Product hierarchy no. *			Part no.	SBU	Type / Description	Customer part no.
SBU PG	PGU	Type				
02 006	016	0000001605	See list below	Power Entry Module with Filter	5150

2 Type of change

5150					0118.2253	
creation date	created by	release date	released by	notification no.	revision	page
2014-12-17	buechlp	2015-01-20	buechlp	26907	-	1 of 2

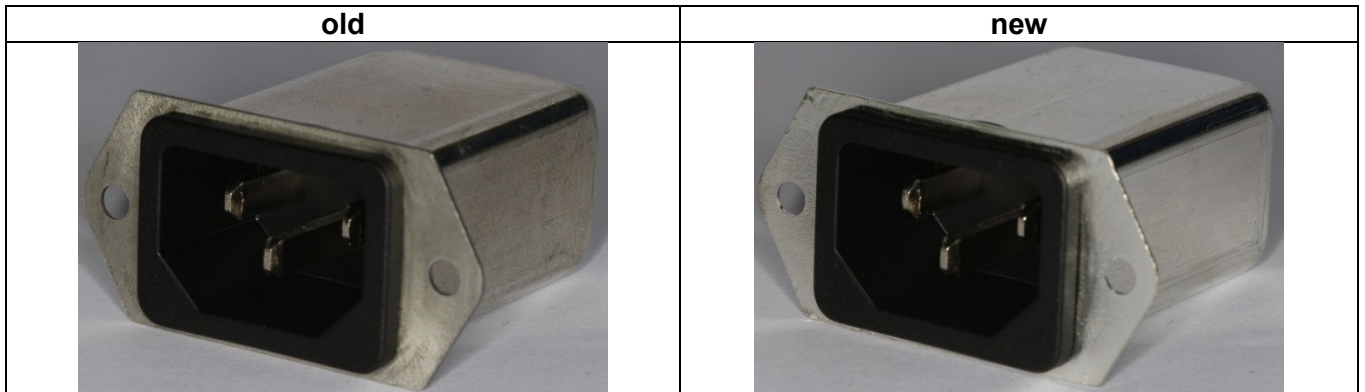
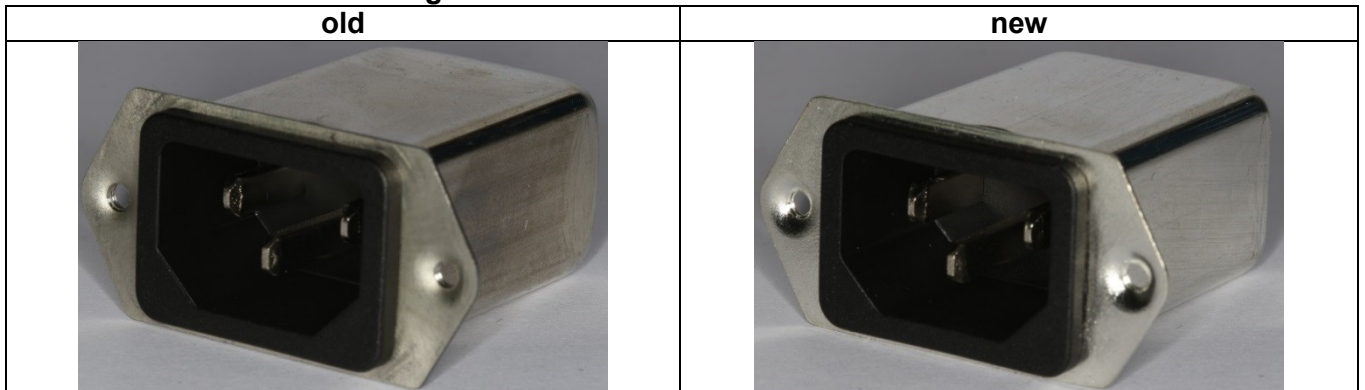
Filter cases for front and rear mounting have a new surface treatment process in order to product improvement.

Surface treatment process of filter case has changed with no change of surface material.

Screw versions front-side

Screw versions rear-mounting

Form:	No	No change to form but more shiny surface
Fit:	No	There are no dimensional changes
Function:	Yes	Improved resistance against corrosion
Production Site:	No	There is no change of the production site
Product Label:	No	No change to product label
Customer action	No	Notification only
